## Intel Haswell rPGA Processor with Lynx Point-H

Viper MXM

Version 0.5

Security Classification	Compal Secret Data			Compal Electronics, Inc.	
Issued Date	2011/06/29	Deciphered Date	2011/06/29	Title	Cover Page
THIS SHEET OF ENGINEERING DRAWING IS THE PROPRIETARY PROPERTY OF COMPAL ELECTRONICS, INC. AND CONTAINS CONFIDENTIAL AND TRADE SECRET INFORMATION. THIS SHEET MAY NOT BE TRANSFERRED FROM THE CUSTODY OF THE COMPETENT DIVISION OF PRODUCT CUSTOMER SERVICE DEPARTMENT EXCEPT AS AUTHORIZED BY COMPAL ELECTRONICS, INC. NEITHER THIS SHEET NOR THE INFORMATION IT CONTAINS MAY BE USED BY OR DISCLOSED TO ANY THIRD PARTY WITHOUT PRIOR WRITTEN CONSENT OF COMPAL ELECTRONICS, INC.				Document Number	Rev
				LA-9241P	0.5
				Date: Thursday, December 20, 2012	Sheet 1 of 56

# +1.35VS Source

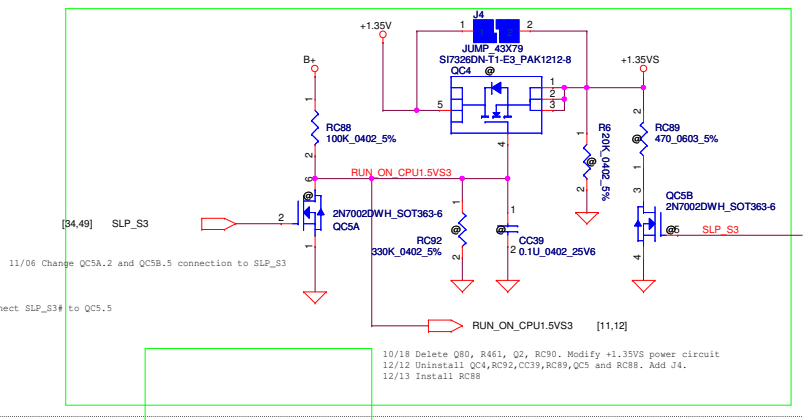
09/11 Delete RC93 and connect SLP\_S3# to OC5.5

11/06 Change OC5A.2 and OC5B.5 connection to SLP\_S3

10/18 Delete Q80, R461, Q2, RC90. Modify +1.35VS power circuit  
12/12 Uninstall CC4, RC92, CC39, RC89, QC5 and RC88. Add J4.  
12/13 Install RC88

10/16 Add Q80

# VCC\_SENSE

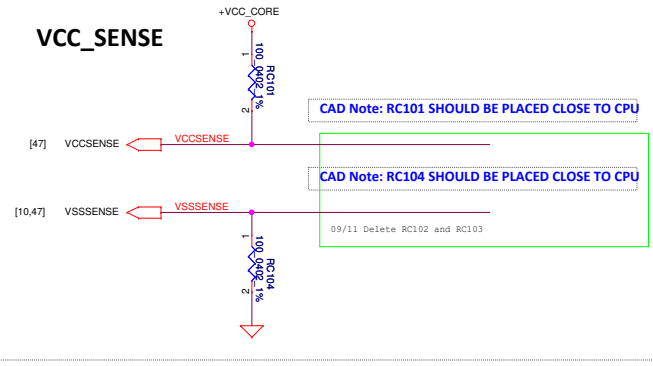
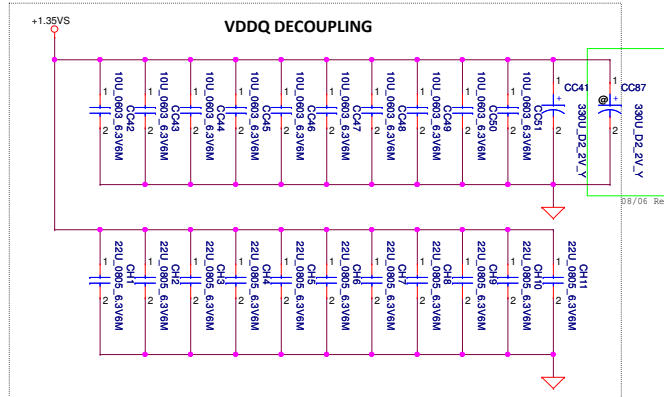
09/11 Change netname to VCCSENSE

09/11 Delete RC102 and RC103

08/06 Reserve CC87

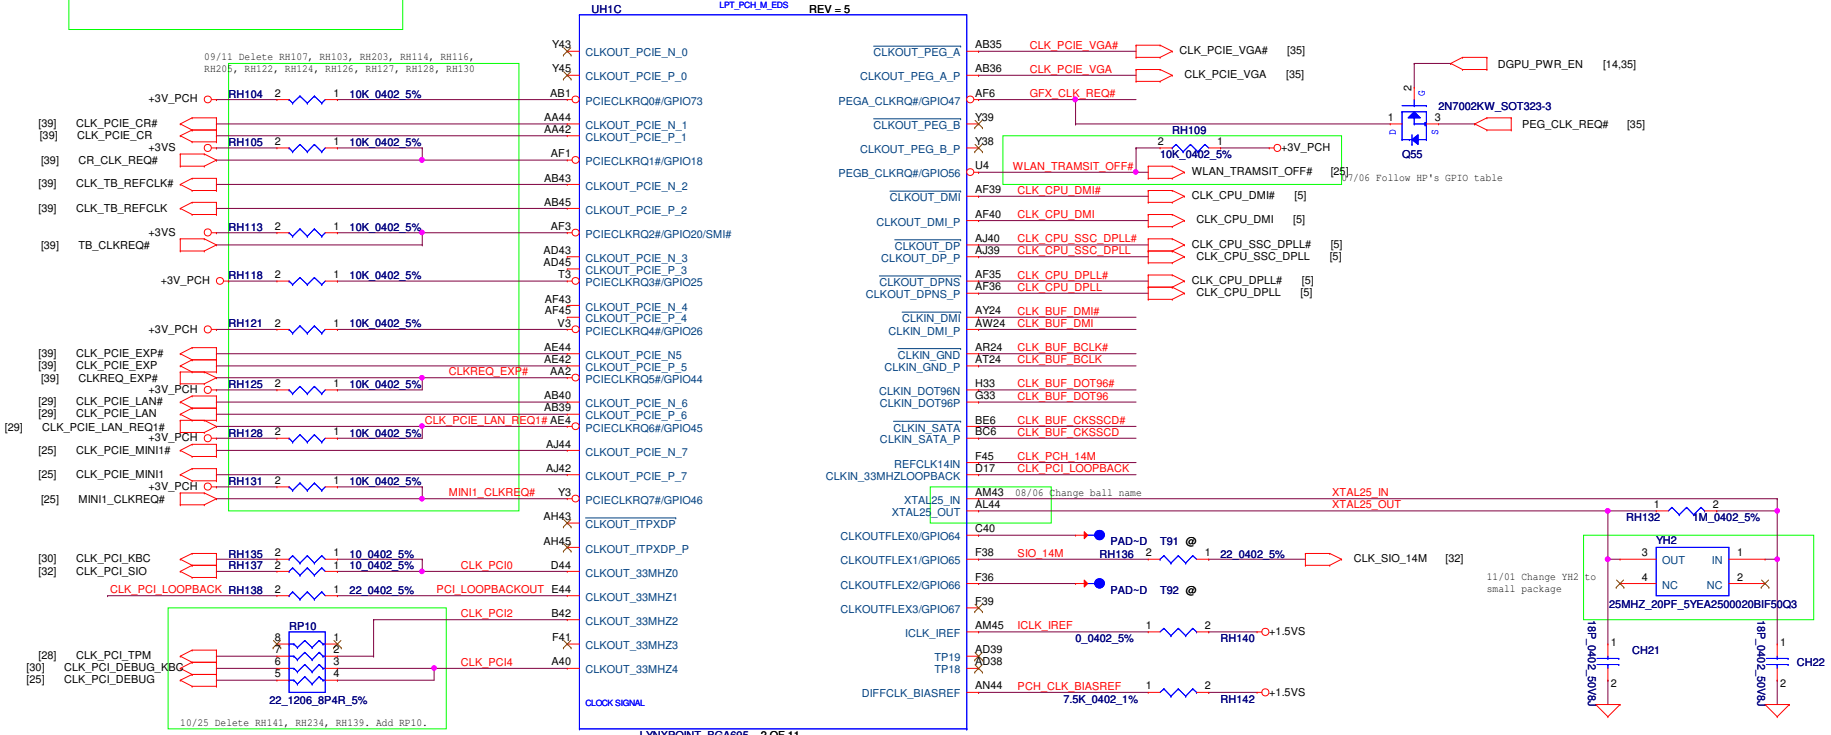
07/23 Delete FN14 and FN15 off page symbol

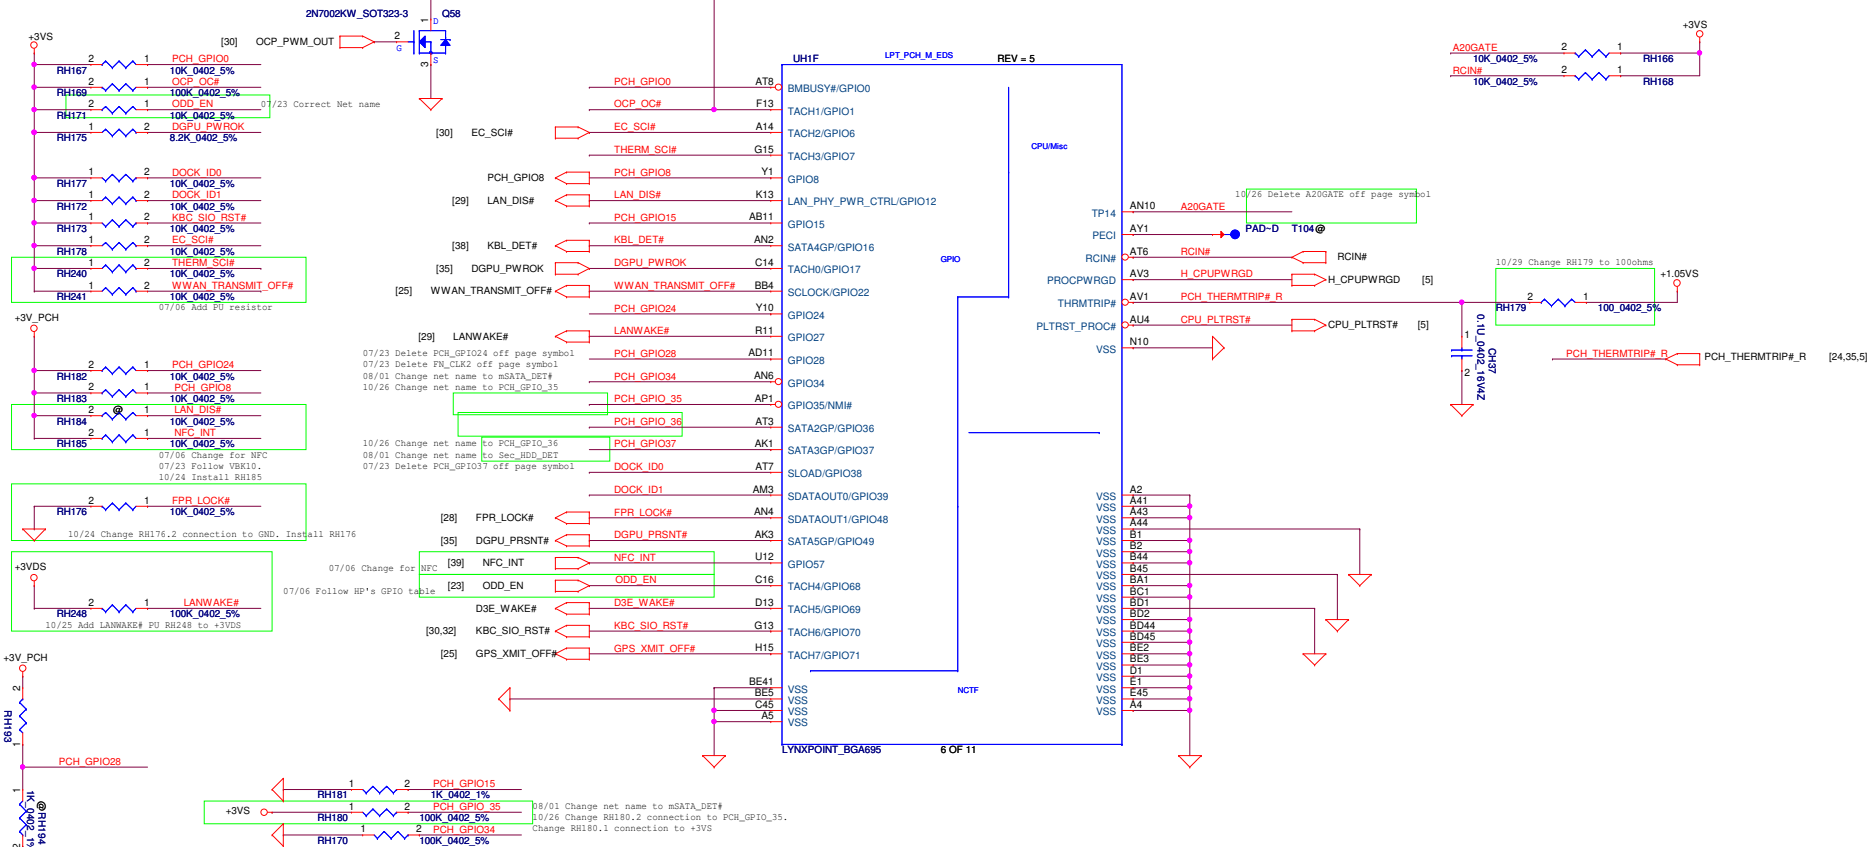
08/01 Change net name to Sec\_HDD\_DET  
10/26 Change netname to PCH\_GPIO\_36

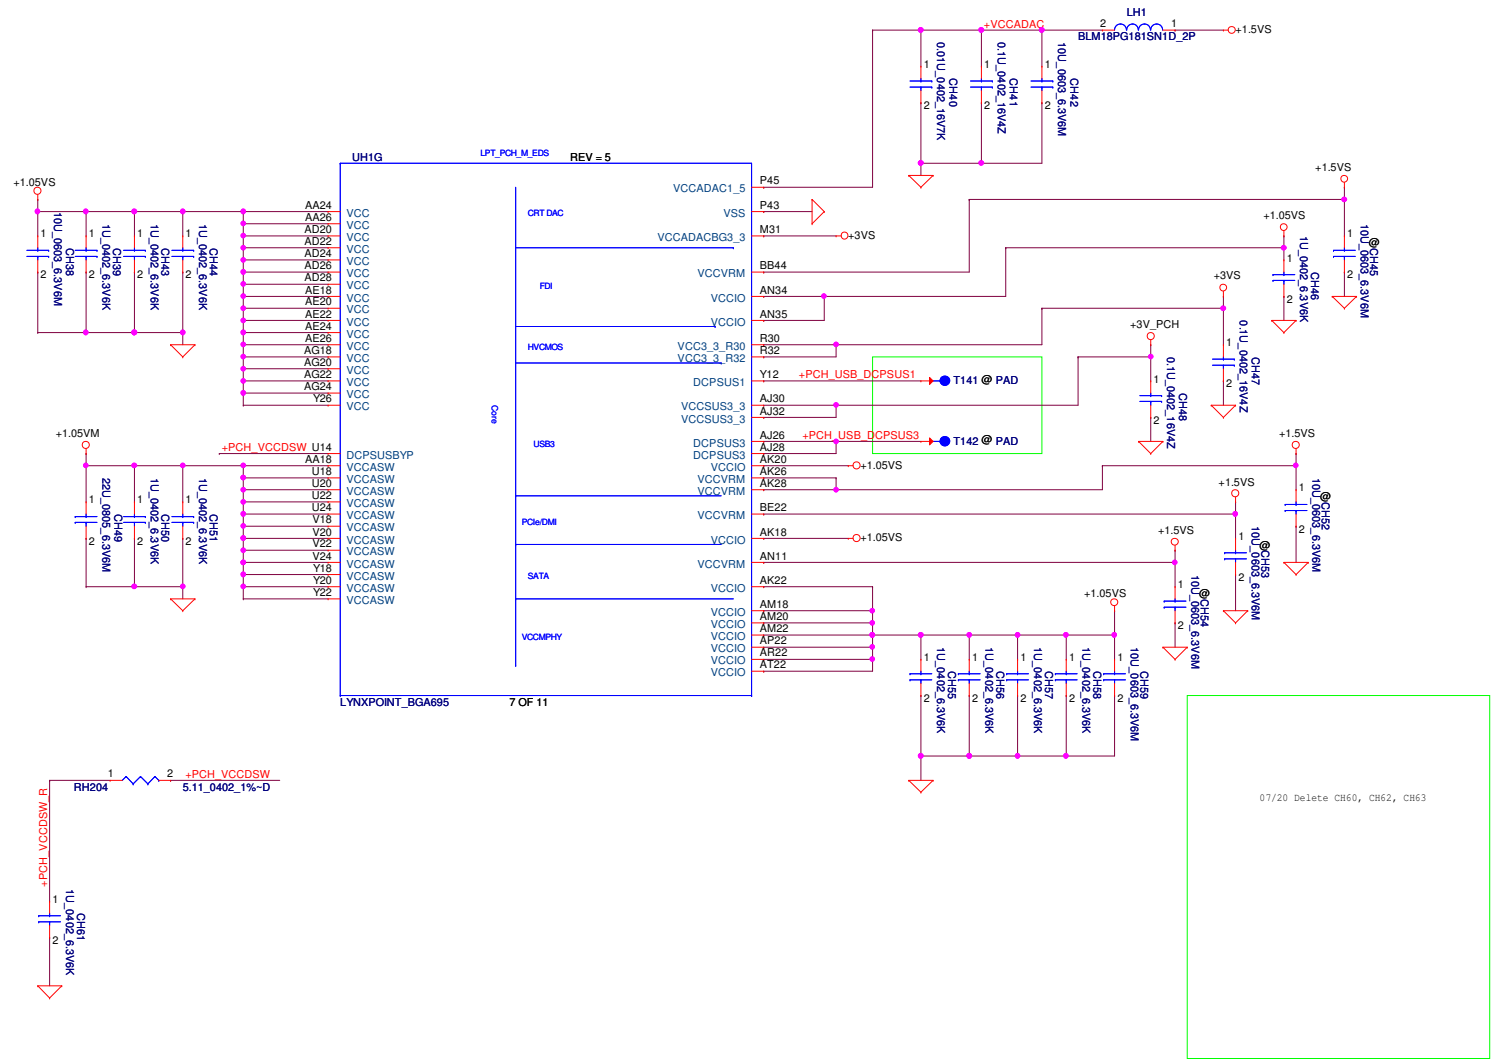
07/20 Delete CH60, CH62, CH63

# Thunderbolt

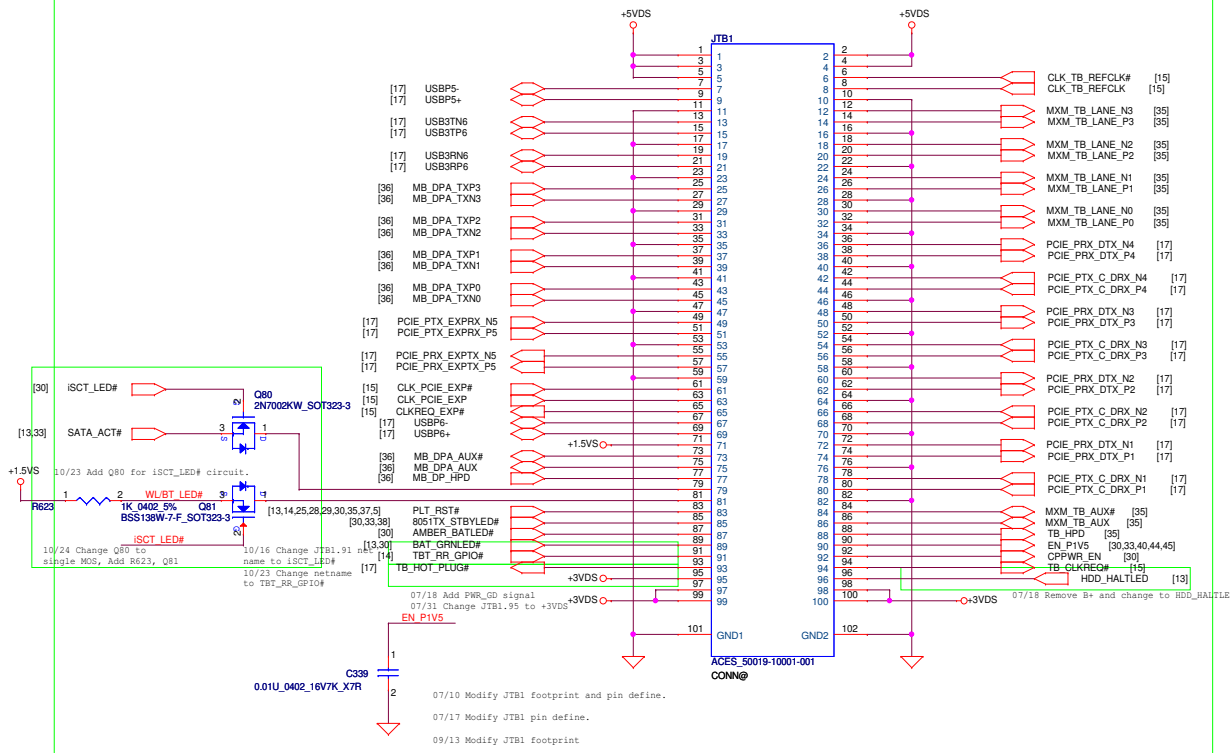
10/23 Add Q80 for iSCT\_LED# circuit.  
10/24 Change Q80 to 1K 0402 5% BSS138W-7-F\_SOT323-3  
10/23 Change netname to TB\_RST\_PLUG#  
10/16 Change JTB1.91 name to iSCT\_LED#  
10/23 Change netname to TB\_RST\_PLUG#  
07/18 Add PWR\_CD signal  
07/31 Change JTB1.95 to +3VDS  
07/18 Remove B+ and change to HDD\_HALTED  
07/10 Modify JTB1 footprint and pin define.  
07/17 Modify JTB1 pin define.  
09/13 Modify JTB1 footprint.

# USB3.0 Repeater

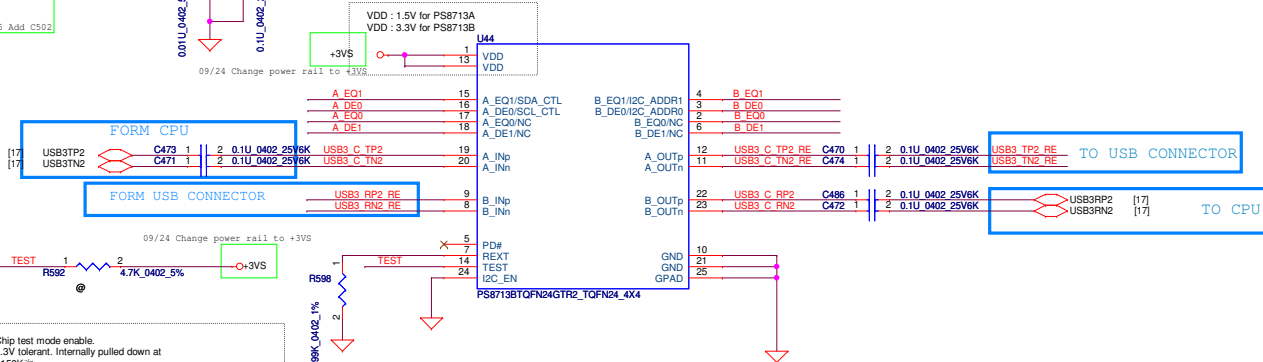
Follow ESD team recommend change ESD diode D5 D6  
20120713

# USB3.0 Connector

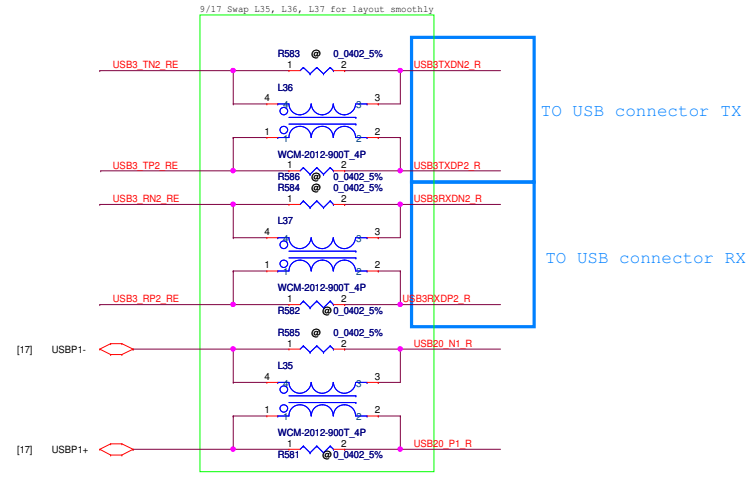
9/13 Modify JUSB1 footprint and pin define

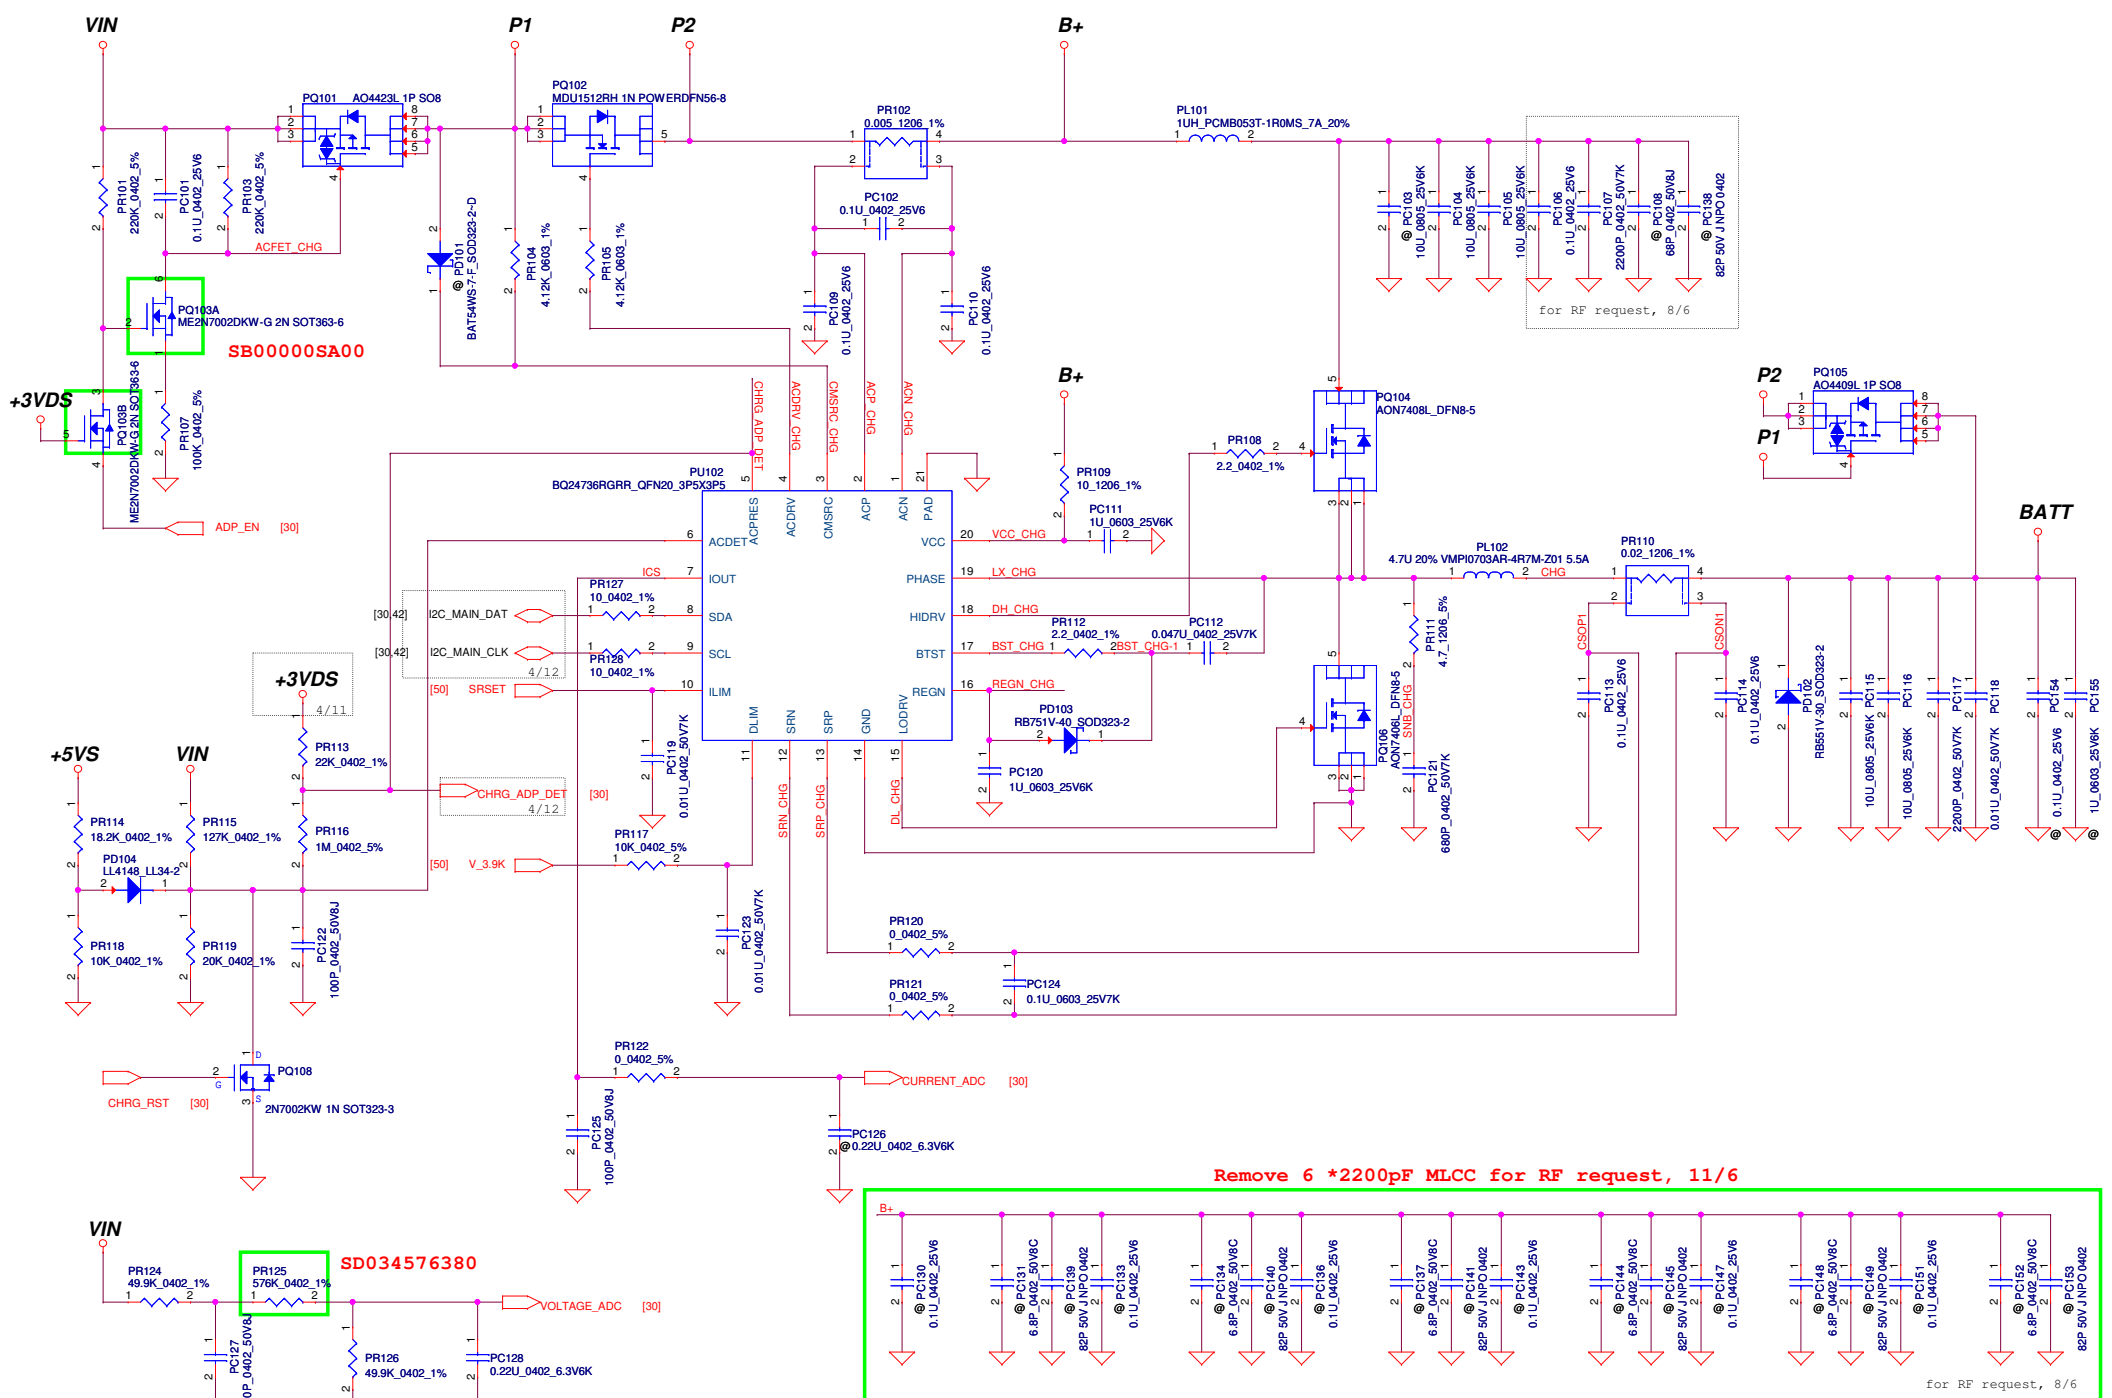
for RF request, 8/6

Remove 6 \*2200pF MLCC for RF request, 11/6

for RF request, 8/6
